METROPOLITAN GOVERNMENT OF NASHVILLE AND DAVIDSON COUNTY

STAFF RECOMMENDATION
1628 Fatherland Street
February 20, 2013

Application: New Construction—Addition
District: Lockeland Springs-East End Neighborhood Conservation Zoning Overlay
Council District: 06
Map and Parcel Number: 08314018500
Applicant: Nick Dryden
Project Lead: Melissa Baldock, melissa.baldock@nashville.gov

<p>Description of Project: Application is to construct an addition to a commercial structure. The addition will be taller than the historic building.</p> <p>Recommendation Summary: Staff recommends approval of the project with the condition that staff review and approve the standing seam metal color and any railing installed on the historic structure or addition. With this condition, staff finds that the project meets Section II.B. of the <i>Lockeland Springs-East End Neighborhood Conservation District: Handbook and Design Guidelines</i>.</p>	<p>Attachments A: Site Plan B: Elevations</p>
--	--

① SITE PLAN
 SCALE: 3/32" = 1'-0"
 0 8' 16' 24'

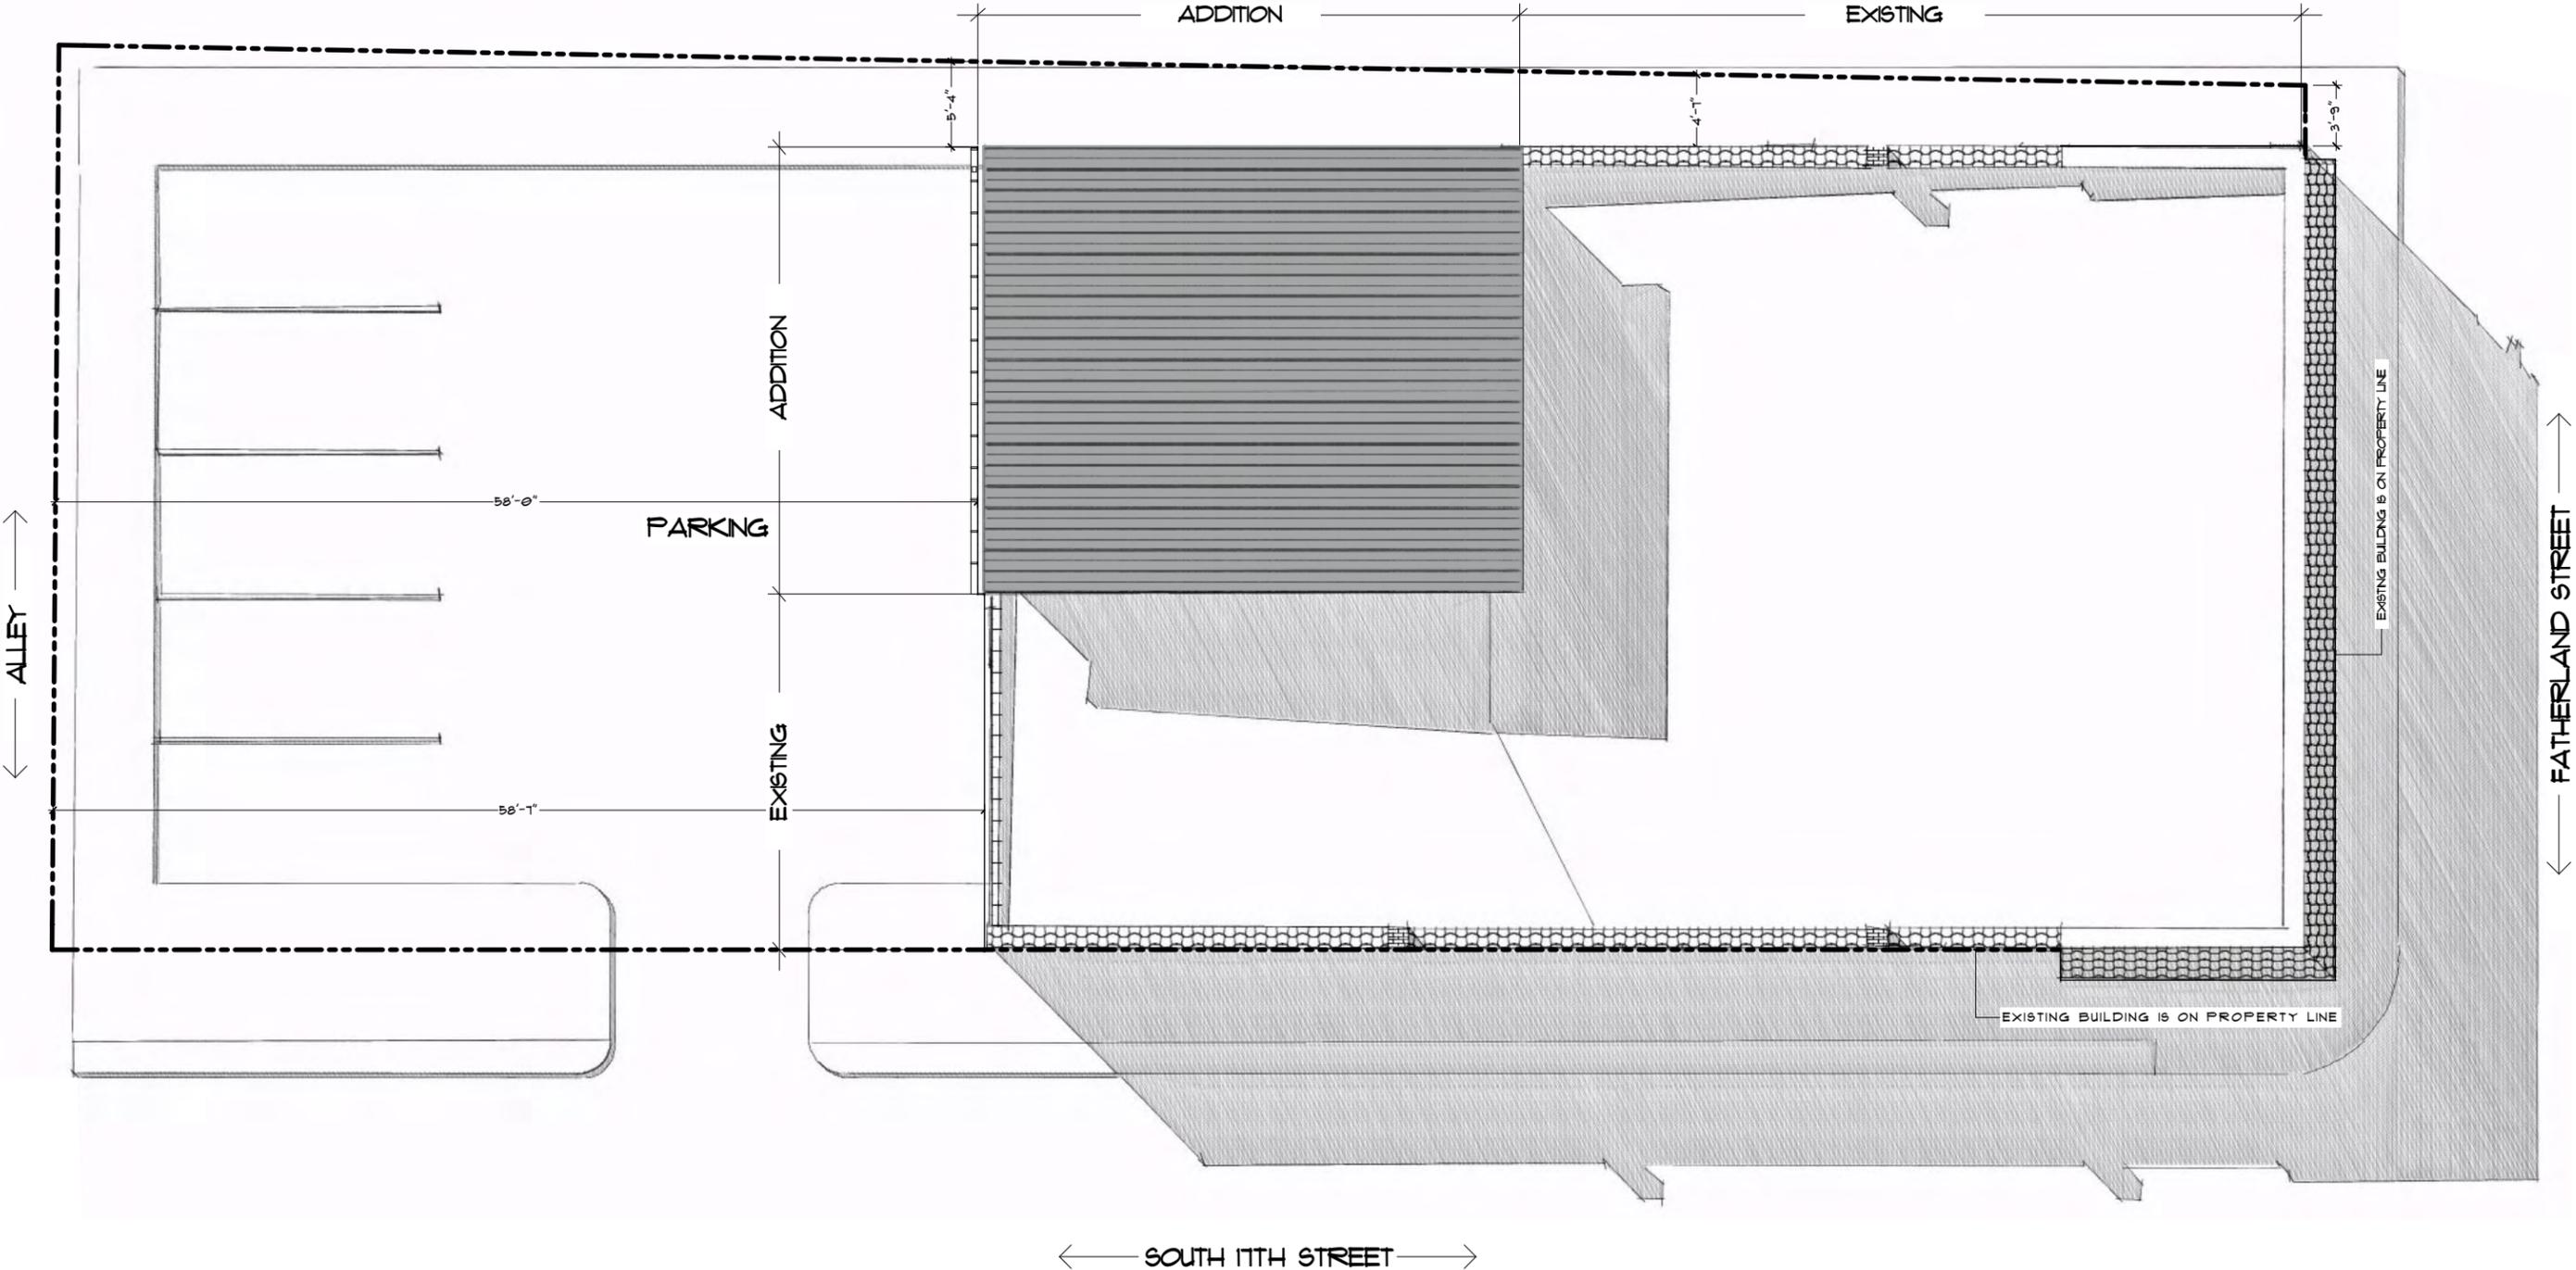
Location, Setback: The proposed addition is located at the rear of the structure, on the right/west elevation, and meets base zoning requirements for setback. The site is zoned

CN for commercial development. Base zoning does not require a setback from the side property lines. The existing structure sits on the left/east property line but is inset from the right/west side property by a minimum of three feet, nine inches (3'9"). The addition will be inset one foot, one inch (1'1") from the existing structure on the right/west elevation and therefore meets the base zoning requirements for setback. Base zoning requires that the structure be more than twenty feet (20') from the rear property line, and the addition will be fifty-eight feet (58') from the rear property line. Staff finds that the addition's location and setback meet Section II.B.1.3. and II.B.10. of the design guidelines.

Appurtenances and Utilities. The drawings do not indicate the location of the utilities, and staff asks that any utilities be placed in the rear of the structure or on the right/west façade, beyond the midpoint of the structure. The site plan indicates that the rear of the property will be used for parking, which is appropriate for a historic commercial structure (see Figure 4). The drawings do not indicate any railings on the historic structure or addition, and staff asks to approve any new railing prior to purchase and installation.

Staff recommends approval of the project with the condition that staff review and approve the standing seam metal color and any railing installed on the historic structure or addition. With this condition, staff finds that the project meets Section II.B. of the *Lockeland Springs-East End Neighborhood Conservation District: Handbook and Design Guidelines*.

① WEST ELEVATION
SCALE: 1/8" = 1'-0" 0 4' 8' 16'

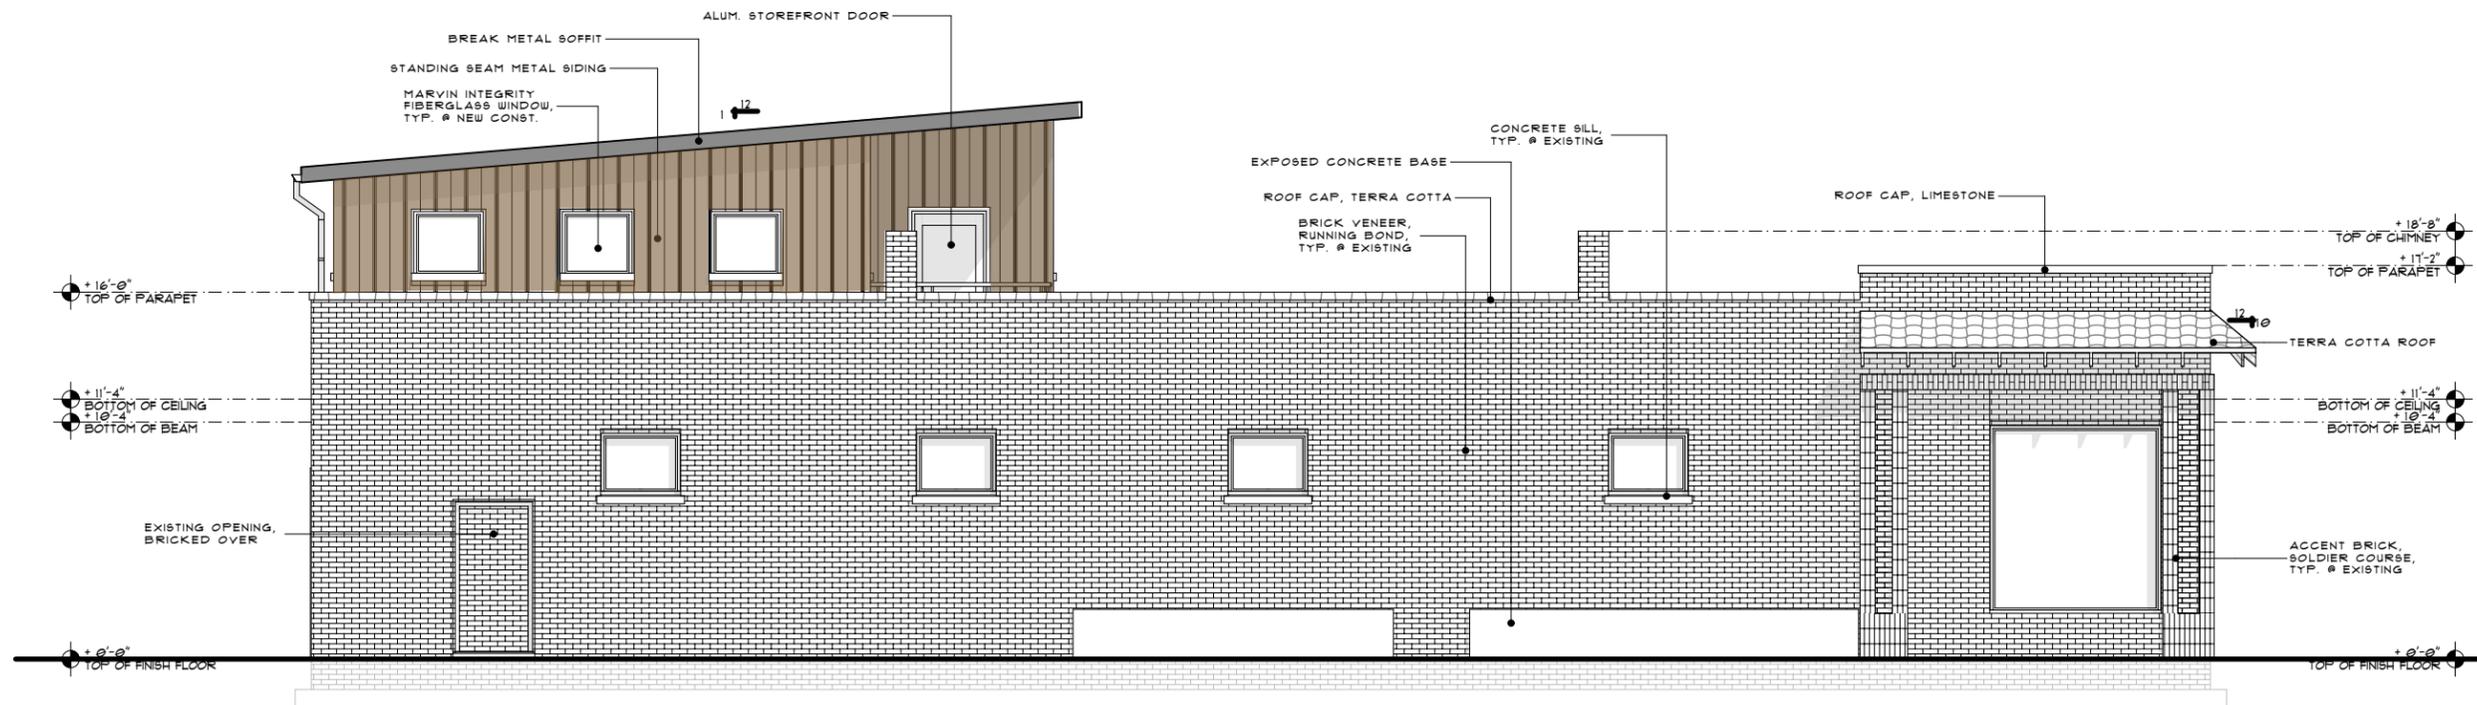
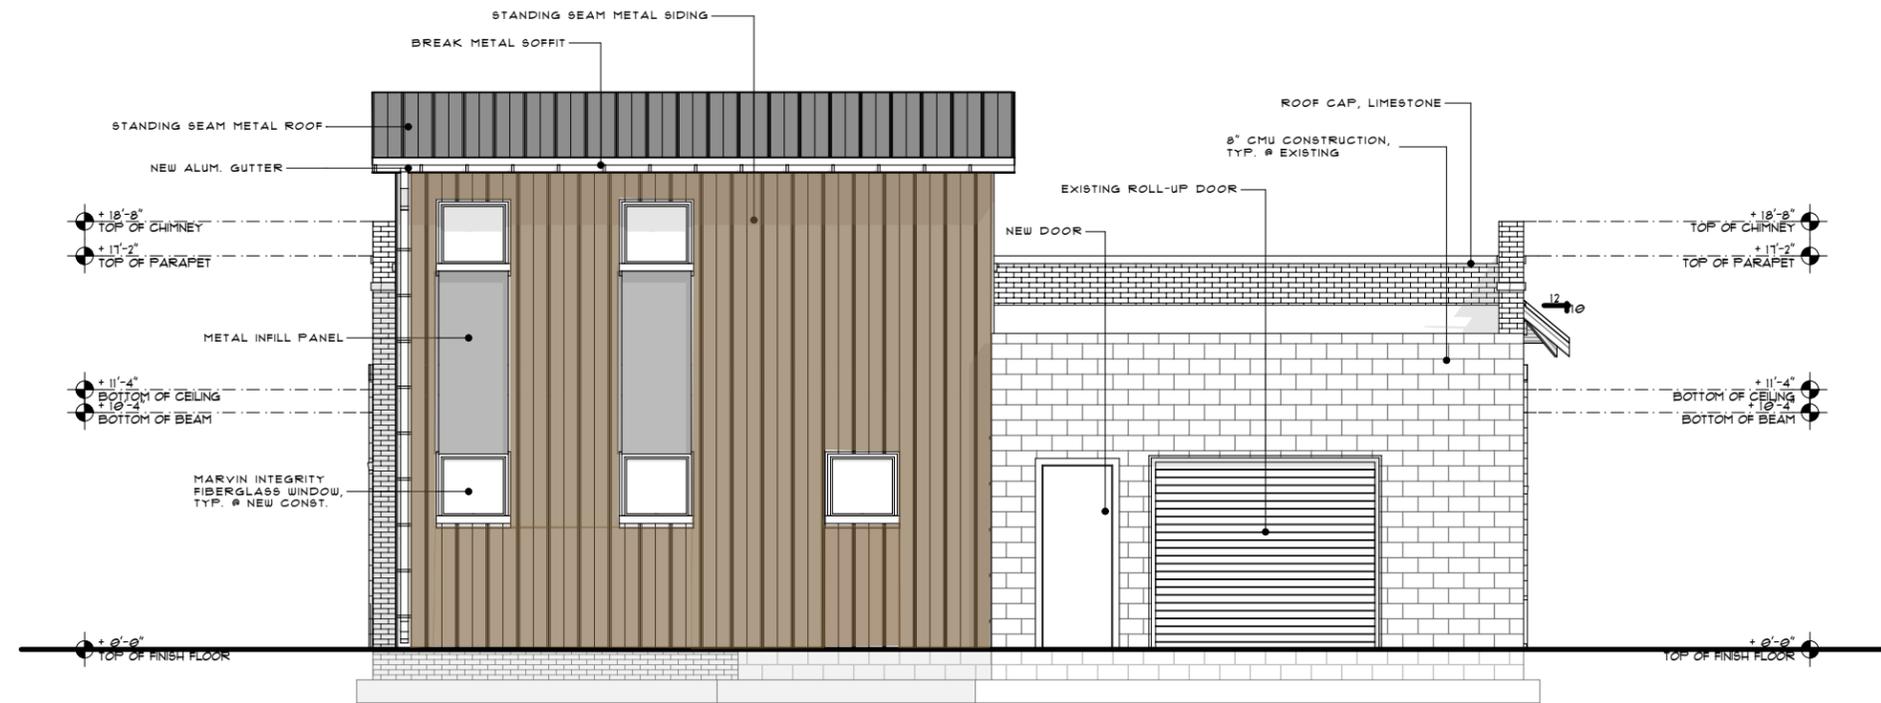
Height, Scale: The proposed addition will be two stories and taller than the one-story historic building. The historic building is approximately nineteen feet, nine inches (19'9") tall at the front and eighteen feet, six inches (18'6") tall at the back where the addition will be located. The proposed addition will be twenty-six feet (26') tall, or eight feet, six inches (8'6") taller than the structure at the back. Staff finds the height of the addition to be appropriate because the addition is located fifty-one feet (51') from the front of the structure on Fatherland, and twenty-three feet, six inches (23'6") from the 17th Street façade, reducing its visual impact on the historic building (See Figure 2). The addition will appear as a rooftop addition to a commercial structure.

Materials: The existing structure is painted brick with unpainted brick accents and a wood and terra cotta tile overhang on Fatherland Street. The new addition will be clad in standing seam metal siding with a standing seam metal roof. Although metal siding is not typically approved in the Lockeland Springs-East End district, staff finds it to be appropriate in this instance because the historic structure is a commercial structure and the addition will be placed in the interior portion of the rear of the lot, lessening its visibility. Staff asks to approve the standing seam metal color prior to purchase and installation of the material. The addition's windows will be Marvin Integrity fiberglass windows, and the door will be an aluminum storefront door, both of which are appropriate for commercial structure. With the final approval of the standing seam metal color, staff finds that the structure's materials meet Sections II.B.4. and II.B.10. of the design guidelines

Roof Form: The existing structure has a flat roof, as is typical of historic commercial structures. The proposed addition will have a shed roof with a slope of approximately 1/12. Staff finds that the roof form is compatible with that of the historic structure, is appropriate for a commercial structure, and meets Sections II.B.1.5. and II.B.10. of the design guidelines.

Proportion and Rhythm of Openings: The drawings indicate that the window and door openings on the existing structure will not be altered as part of this project. The addition's windows will be three feet (3') square, and will be similar to the three feet by two feet, six inch (3' X 2'6") windows found on the 17th Street façade of the structure. There are no window openings proposed for the ground floor of the right/west façade, resulting in a wall space of approximately thirty-one feet (31') without a window or door opening. Staff finds this expanse of wall space to be appropriate for a commercial structure's secondary façade that faces the interior of the block. This portion of the façade will be at most minimally visible. Staff finds that the addition's proportion and rhythm of openings meet Section II.B.7. and II.B.10. of the design guidelines.
